3177-96K 10216 Capitol View Avenue  
(Capitol View Park Historic District)

HISTORIC PRESERVATION COMMISSION STAFF REPORT

Address: 10216 Capitol View Avenue

PROPOSAL: Construction of new single-family  
1-1/2 story house w/deck;  
Removal of six trees

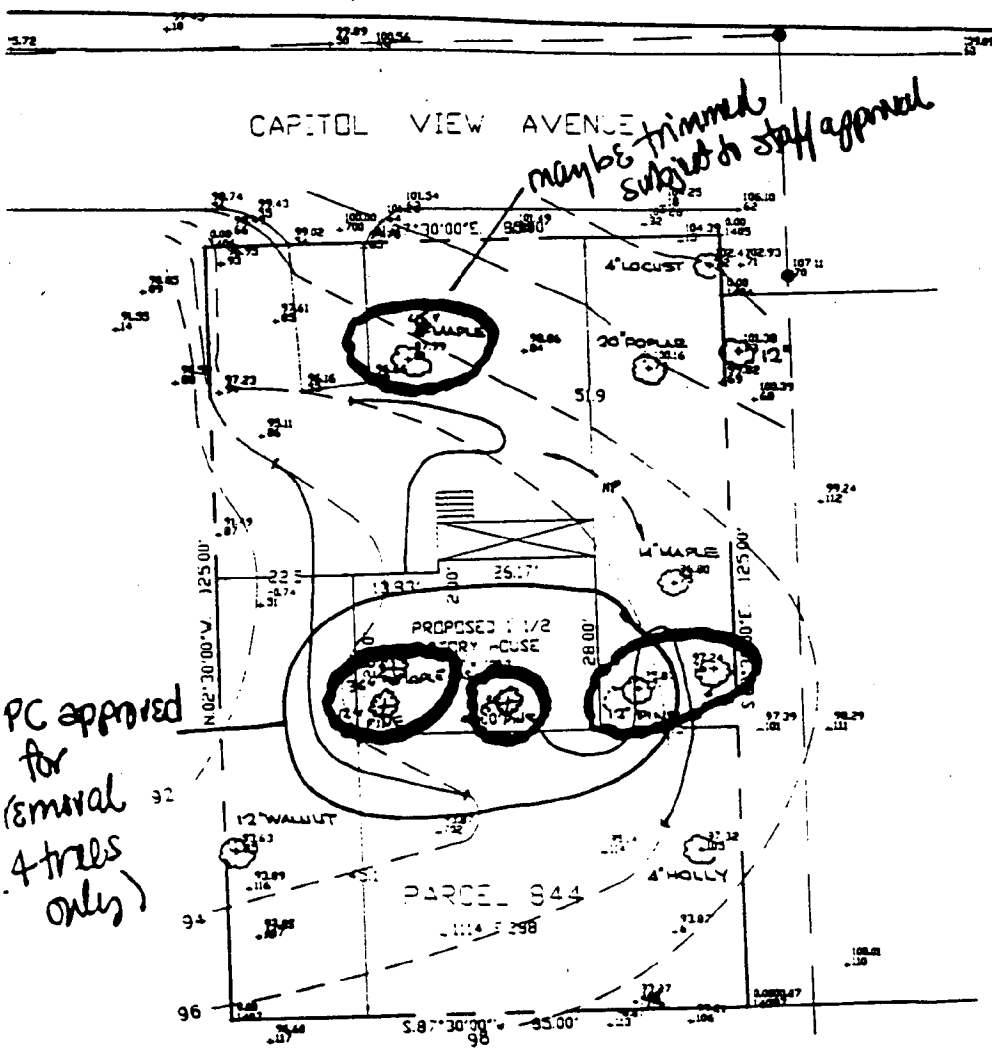
On September 25, 1996, the Historic Preservation Commission (HPC) approved a Historic Area Work Permit to remove two 12" pine trees, one 15" pine tree and a 36" maple tree. The HPC **did not approve** removing the 45" maple or the 12" pine tree located closest to the property line. I have attached a copy of your site plan (to be used as a reference) with those trees marked that were approved for removal.

However, you may remember that the HPC approved trimming certain limbs of the 45" maple tree. Therefore, HPC Staff will make a site visit on Monday, October 7, 1996 to meet with your contractor concerning the amount of excavation necessary to construct the new house as proposed. And at that time, we have requested an M-NCPPC arborist to also make a site visit to determine which limbs of the 45" maple could be removed.

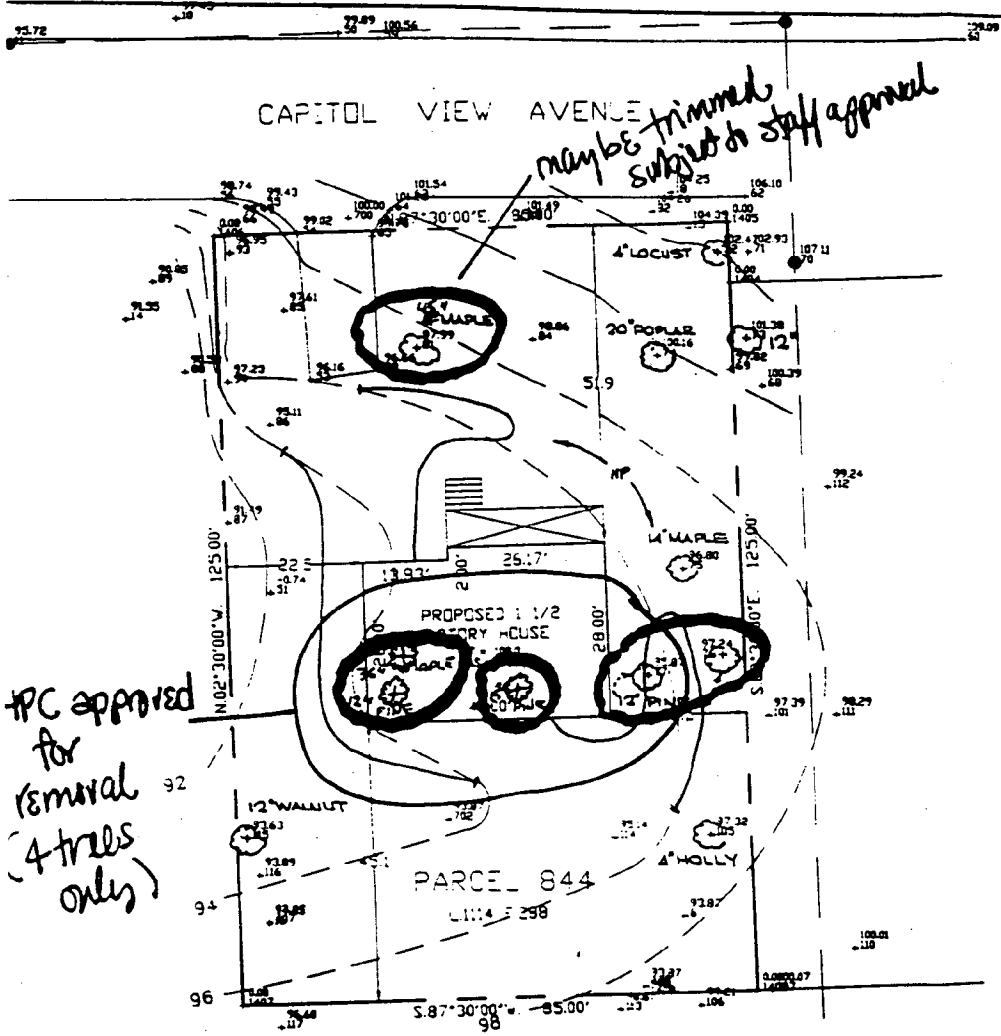
On September 25, 1996, the Historic Preservation Commission (HPC) approved a Historic Area Work Permit to remove two 12" pine trees, one 15" pine tree and a 36" maple tree. The HPC **did not approve** removing the 45" maple or the 12" pine tree located closest to the property line. I have attached a copy of your site plan (to be used as a reference) with those trees marked that were approved for removal

*IPC approved for removal (4 trees only)*

*maybe trimmed subject to staff approval*

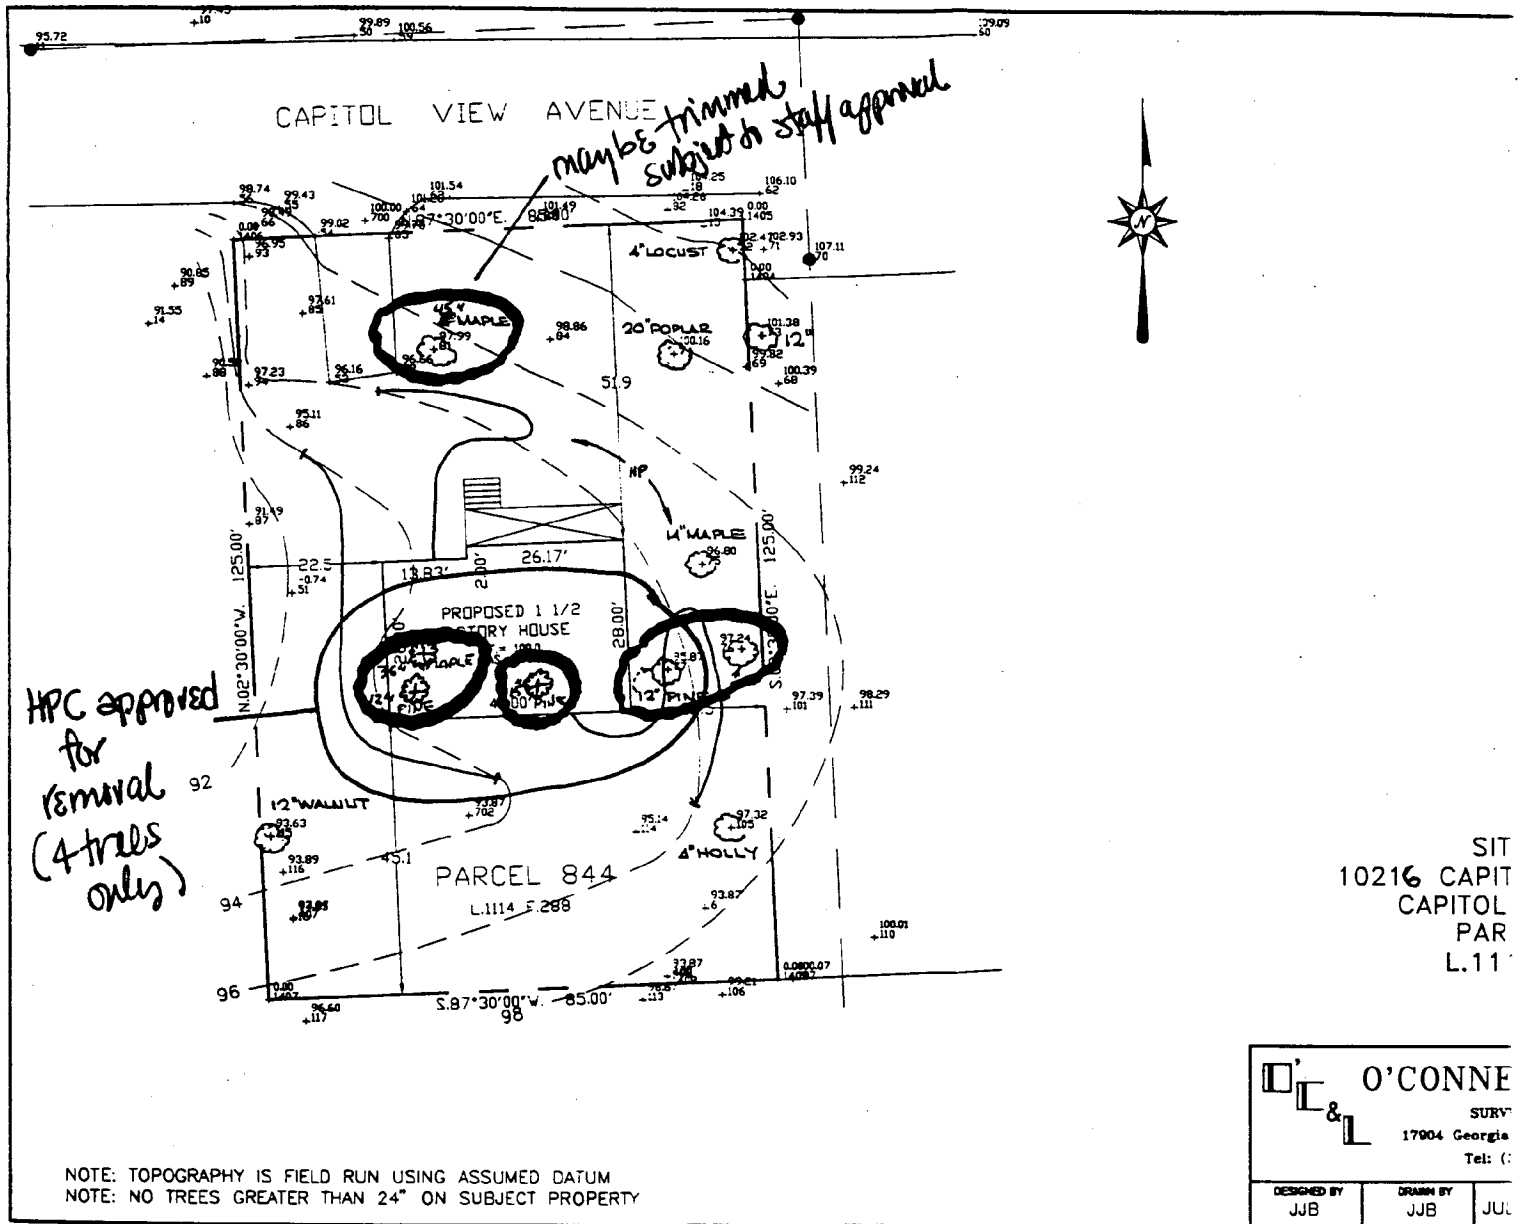
On September 25, 1996, the Historic Preservation Commission (HPC) approved a Historic Area Work Permit to remove two 12" pine trees, one 15" pine tree and a 36" maple tree. The HPC **did not approve** removing the 45" maple or the 12" pine tree located closest to the property line. I have attached a copy of your site plan (to be used as a reference) with those trees marked that were approved for removal.

However, you may remember that the HPC approved trimming certain limbs of the 45" maple tree. Therefore, HPC Staff will make a site visit on Monday, October 7, 1996 to meet with your contractor concerning the amount of excavation necessary to construct the new house as proposed. And at that time, we have requested an M-NCPPC arborist to also make a site visit to determine which limbs of the 45" maple could be removed.

SITE PLAN  
1021<sup>6</sup> CAPITOL VIEW AVENUE  
CAPITOL VIEW PARK  
PARCEL 844  
L.1114 F.288

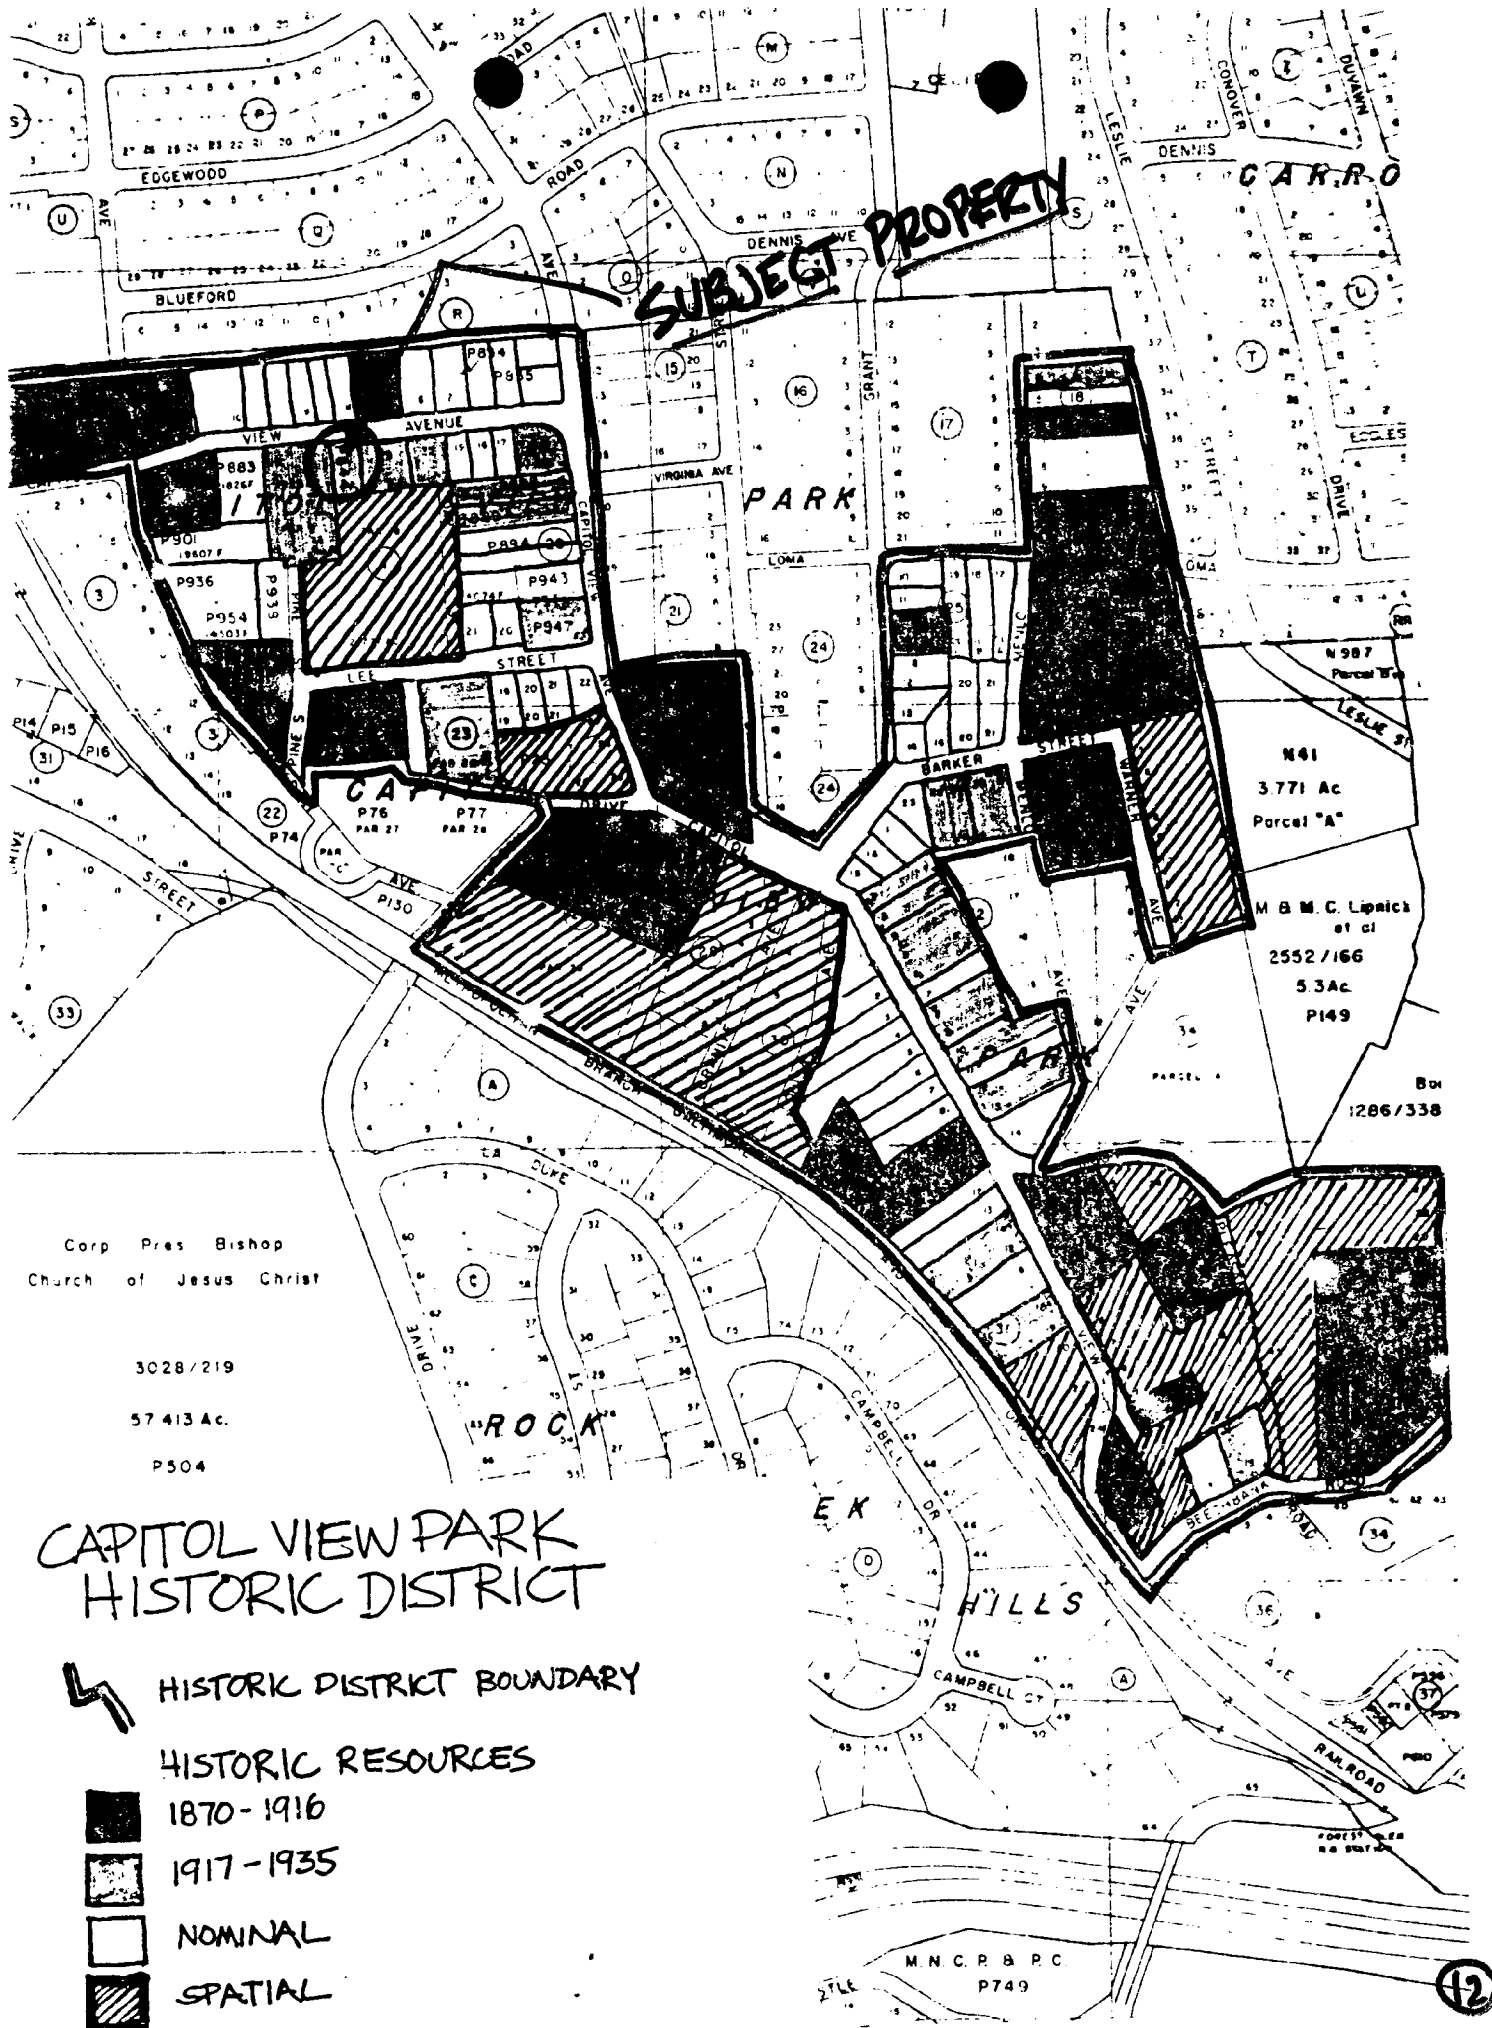
LAP appears of small size of house & general style but finds insufficient information on how house would fit on Lot, ie no information on Grading. Also we have not seen tree plan. Our information says no tree removal under 24" - we need anything over 6". Recommend tabling application pending further review. Thanks

LAP approves of small size of house & general style but finds insufficient information on how house would fit on Lot, ie no information on Grading. Also we have not seen tree plan. Our information says no tree removal under 24" - we need anything over 6". Recommend tabling application pending further review. Thanks
